**Project/File:** **DRAFT Pointe Pierce Villas Subdivision / GCPP24-0002 / SUBFY2024-0002**  
This is a preliminary and final plat application for the development of a 17-unit multifamily development and 8-unit townhouse on 0.83-acres.

**Lead Agency:** Garden City

**Site address:** 405 & 409 E 47<sup>th</sup> Street

# Site Plan

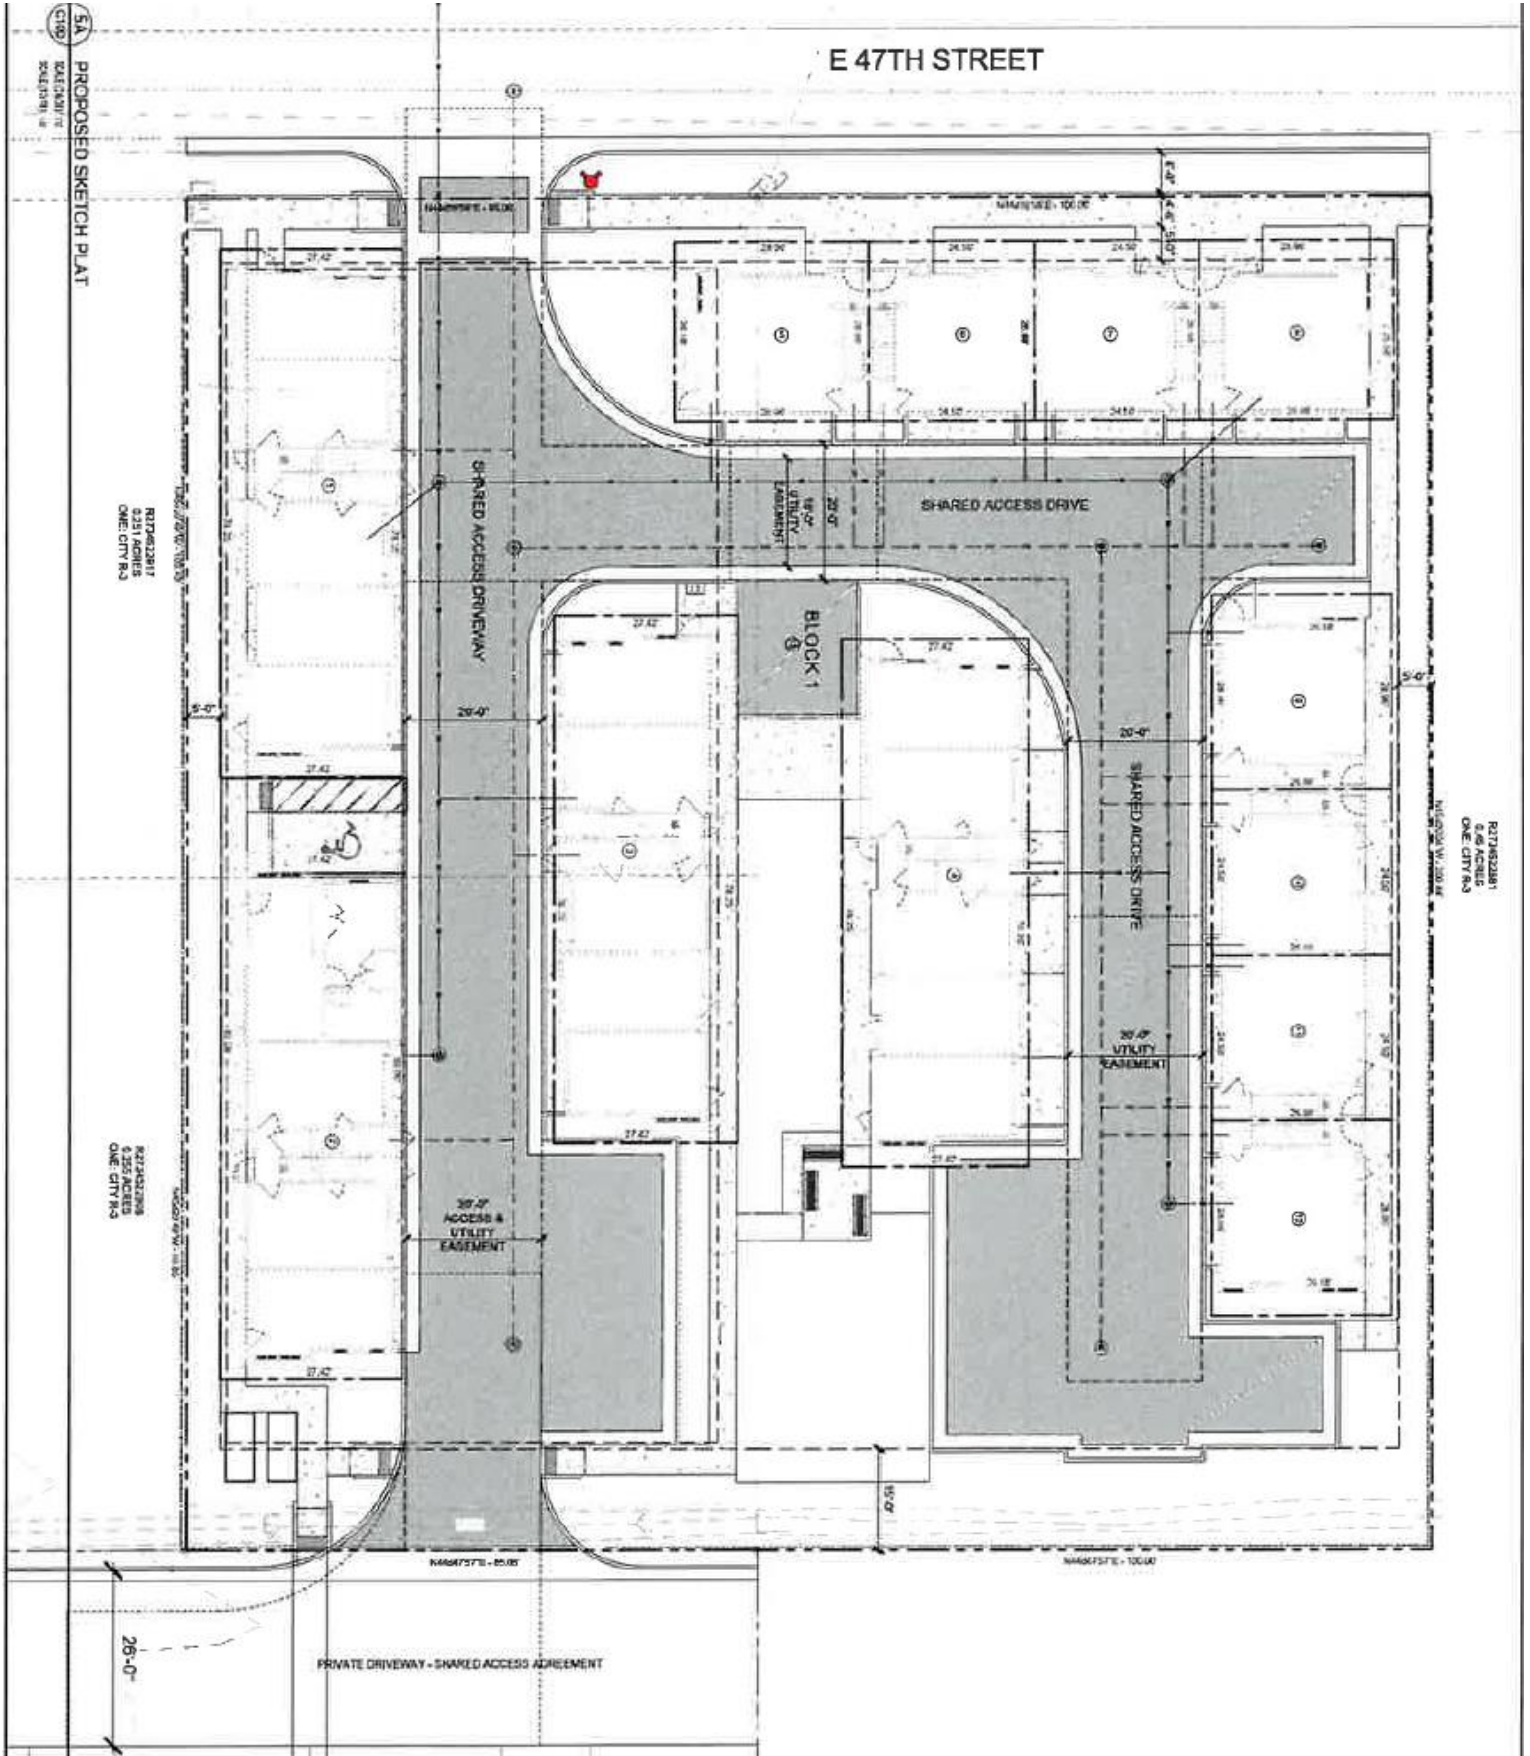
1. Construct 47<sup>th</sup> Street as ½ of a 36-foot commercial street section with curb, gutter, an 8-foot wide planter strip, and 5-foot wide detached sidewalk.

2. Provide a permanent right-of-way easement from 2-feet behind back of curb to 2-feet behind back of sidewalk.
3. Close the existing 73-foot wide paved driveway on 47<sup>th</sup> Street located 177-feet east of Adams Street and 10-foot wide unimproved driveway on 47<sup>th</sup> Street 286-feet east of Adams Street driveways with curb, gutter, and 5-foot wide sidewalk.

4. Construct a 20-foot wide shared access curb-return type driveway located 181-feet east of Adams Street.
5. Submit civil plans to ACHD Development Services for review and approval. The impact fee assessment will not be released until the civil plans are approved by ACHD.
